EFM8 Laser Bee

EFM8LB1 Errata

This document contains information on the EFM8LB1 errata. The latest available revision of this device is revision C. Note that revision C devices omit the crystal oscillator. Applications requiring a crystal should specify a revision B part number.

Errata effective date: November, 2022.

3.3 PKG_E101 – Top Marking Right Justified

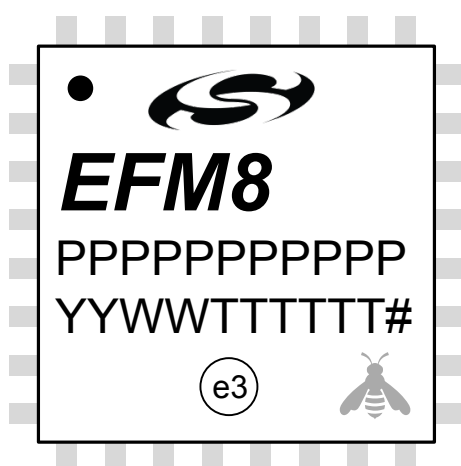
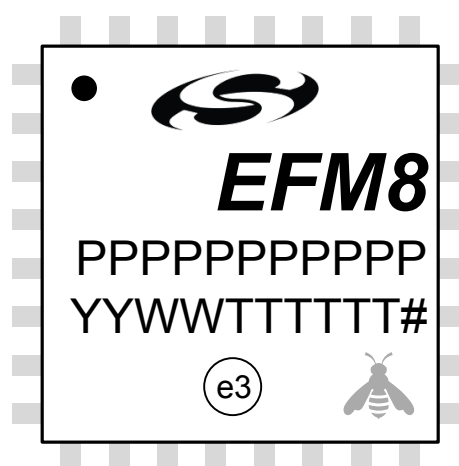
The Package Marking diagrams indicate that the package marking is left justified. However, QFP32 devices with the 1531 date code have package markings that are right justified.

Assembly houses expecting left-justified package marking may see some parts with right-justified package marking.

This issue only affects revision A QFP32 devices with a date code of 1531. All other devices should match the Package Marking diagrams in the device data sheet.
